UNITED STATES PATENT AND TRADEMARK OFFICE

APPLICATION NO.	FILING DATE	FIRST NAMED INVENTOR	ATTORNEY DOCKET NO.	CONFIRMATION NO.
10/755,700	01/10/2004	Christine M. Greiser	A3182Q-US-NP	3437
7590 07/18/2006			EXAMINER	
Patent Documentation Center			FIDLER, SHELBY LEE	
Xerox Corporation Xerox Square 20th Floor			ART UNIT	PAPER NUMBER
100 Clinton Ave. S.			2861	
Rochester, NY 14644			DATE MAILED: 07/18/2006

DETAILED ACTION

Drawing A: Ink jet array from Fig. 2 of Hoisington, edited for clarification

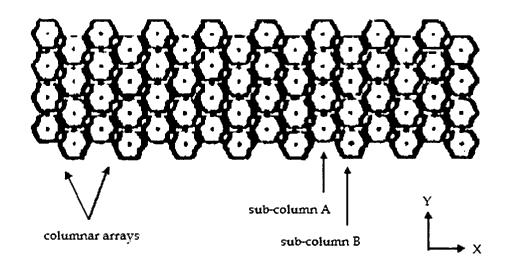
a linear array (e.g. ink jet array 23 of Fig. 2) of side by side substantially mutually parallel columnar arrays (see Drawing A below) of ink drop generators (ink jets 40, Fig. 3), the linear array extending along an X-axis (Drawing A);

each columnar array comprised of a first sub-column of ink drop generators (sub-column A, Drawing A) that is interleaved with a second sub-column of ink drop generators (sub-column B, Drawing B);

*regarding claim 2, the columnar arrays of drop generators comprise linear arrays of drop generators (sub-columns A and B, Drawing A)

*regarding claims 7 and 23, a plurality of finger manifolds (branches 44 and 45, Fig. 3) wherein each first sub-column of drop generators is fluidically connected to a first finger manifold (sub-columns A connected to branches 44, Drawing A and Fig. 3) and each second sub-column of drop generators is fluidically connected to a second finger manifold (sub-columns B connected to branches 45, Drawing A and Fig. 3)

each first columnar array of ink drop generators comprised of a first linear sub-column of ink drop generators (sub-column A, Drawing A) that is interleaved with a second linear sub-column of ink drop generators (sub-column B, Drawing A);

each second columnar array comprised of a third linear sub-column of ink drop generators (sub-column A to array 24, Drawing A) that is interleaved with a fourth linear sub-column of ink drop generators (sub-column B to array 24, Drawing A);

*regarding claim 18, the first columnar arrays of drop generators comprise first linear arrays of drop generators (sub-columns A and B to array 23, Drawing A), and wherein the second columnar arrays of drop generators comprise second linear arrays of drop generators (sub-columns A and B to array 24, Drawing A)

wherein each first columnar array is comprised of first and second linear sub-columns of ink drop generators (sub-columns A and B to array 23, Drawing A) that are interleaved with each other (Fig. 3), and each second columnar array is comprised of third and fourth linear subcolumns of ink drop generators (sub-columns A and B to array 24, Drawing A) that are interleaved with each other (Fig. 3)
